TOWN OF YORKTOWN PLANNING BOARD

PUBLIC MEETING AGENDA YORKTOWN TOWN HALL BOARD ROOM 363 Underhill Avenue, Yorktown Heights, NY 10598

May 9, 2022
7:00 PM

ABACA Memo – Taco Bell Crompond

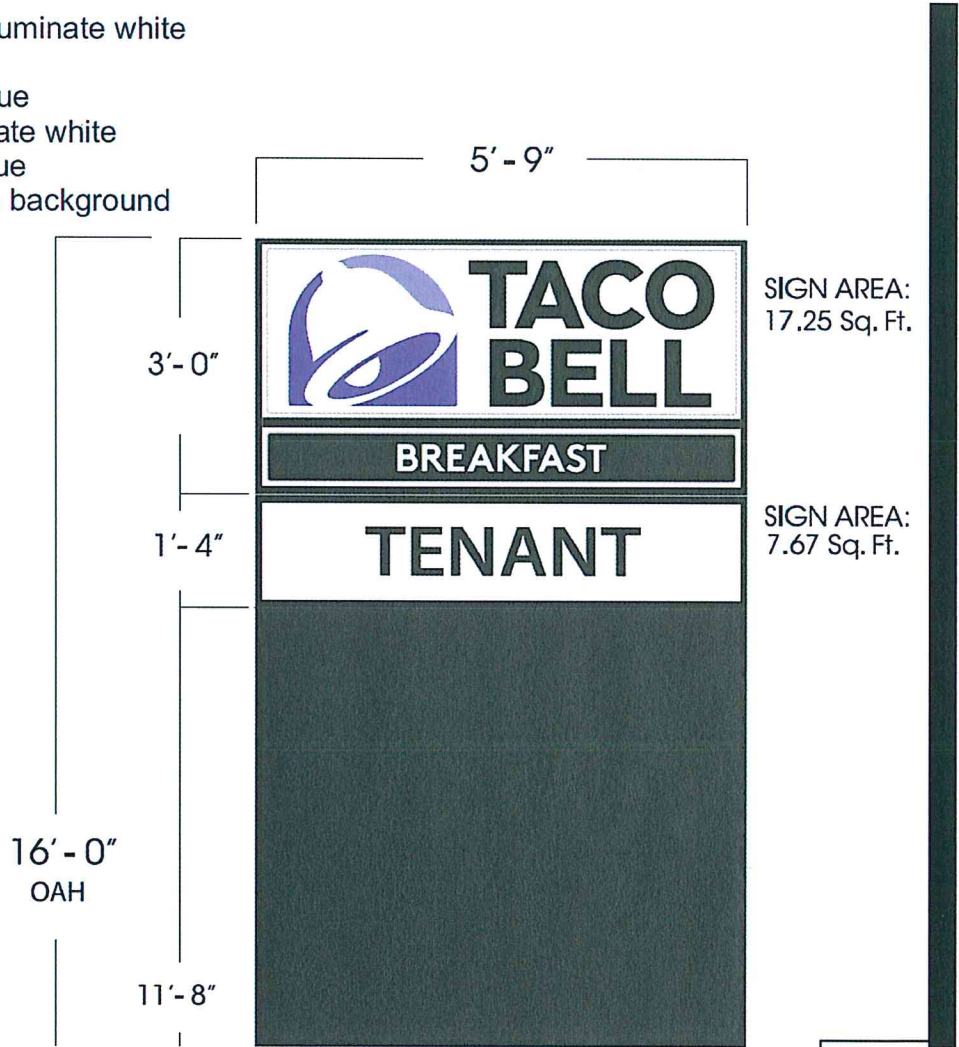
- The overall size of the monument sign is 16’ in height by 5’9” in width with a cement base planter.
- The first panel (sign area is to be 3’ in height by 5’9” in width) will include a bell logo with the words TACO BELL and the words BREAKFAST below. Only the logo and lettering are to illuminate. The TACO BELL black letters are to illuminate white and the Bell logo will illuminate purple on a white opaque background. The BREAKFAST letters and line around are to illuminate white on a black opaque background.
- The second panel (sign area is to be 1’4” in height by 5’ 9” in width) is vacant as there is no tenant proposed at this time. The future tenant sign will have an opaque background with only the lettering and logo to illuminate. Once a tenant becomes available, the applicant will submit an application for review.

OVERALL IMPROVEMENT PLAN

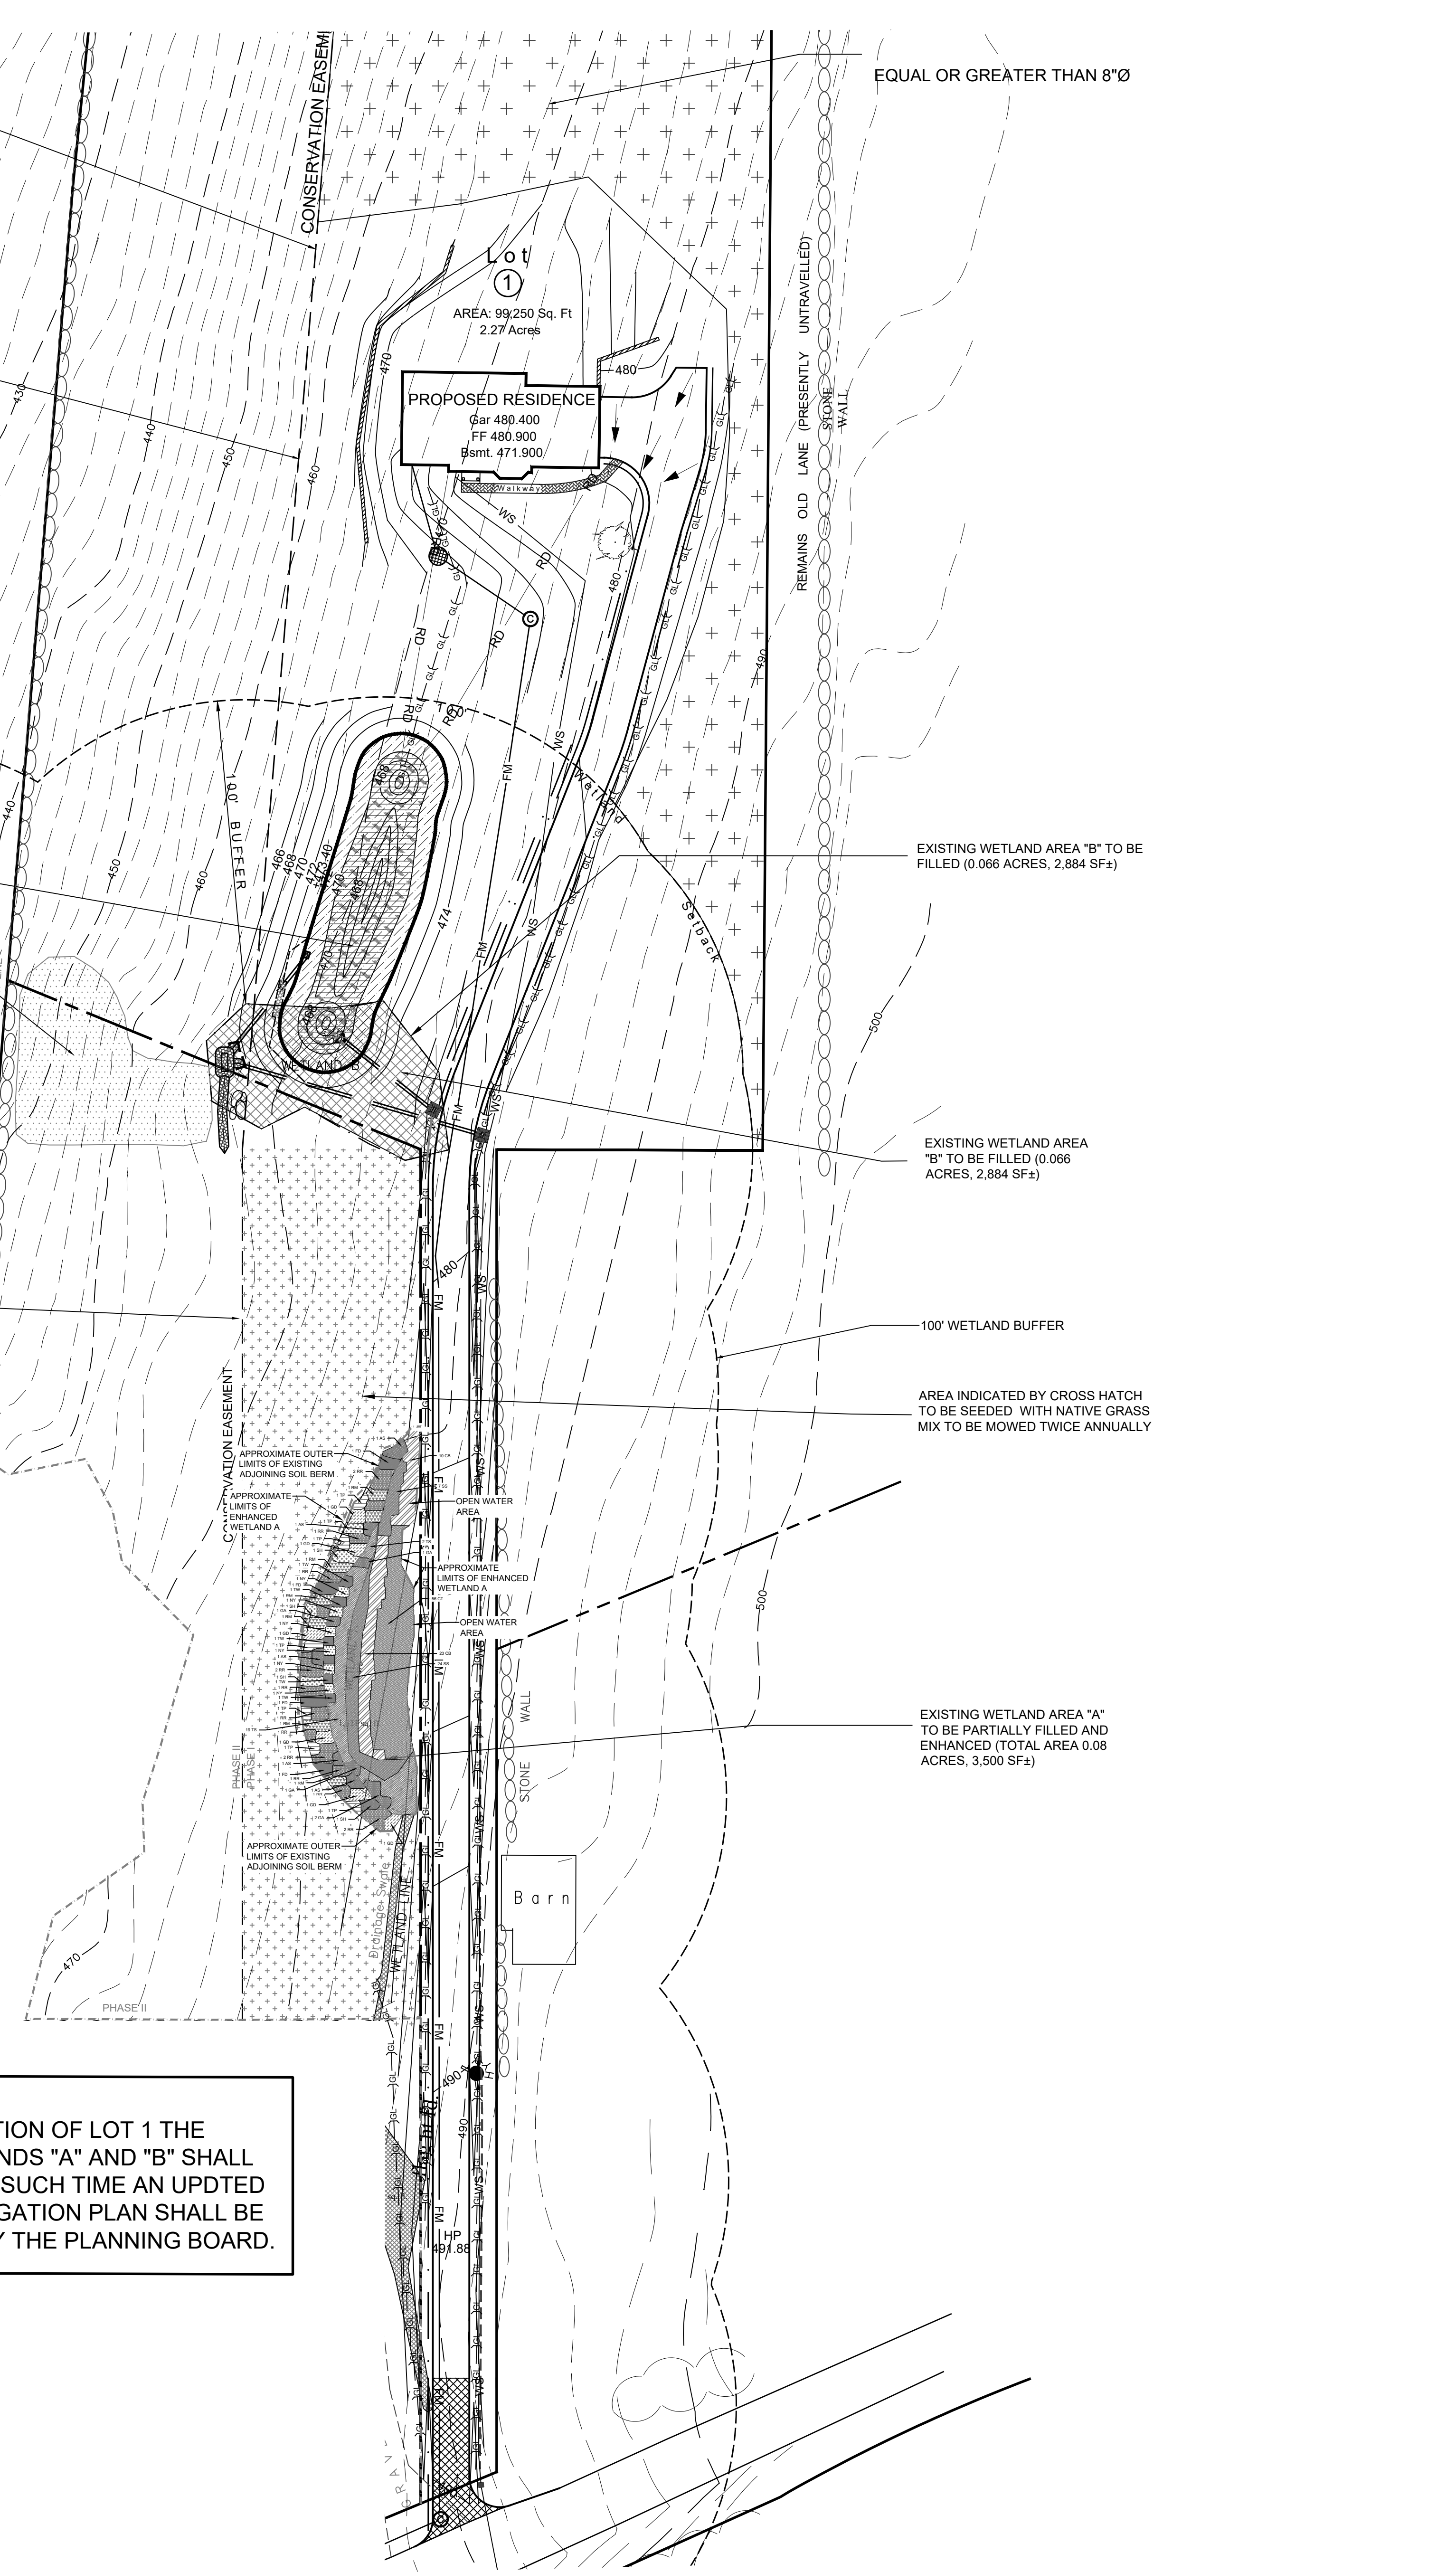
At the 4/20/2022 Conservation Board Meeting, the Board met with Joe Riina of Site Designs to discuss a proposed subdivision located at 1767 Jacob Road. The Board has the following suggestions:

- The applicant should prepare a plan with a delineated conservation easement labeled on it, and monument where applicable.
- A complete planting schedule should be submitted with sizes and names of plants.
- The applicant should use a variety of native plantings to maintain diversity.

AT THE TIME OF DEVELOPMENT OF LOT 1 THE SITE PLAN SHALL DEMONSTRATE THE MEANS OF DELINEATION OF THE CONSERVATION EASEMENT
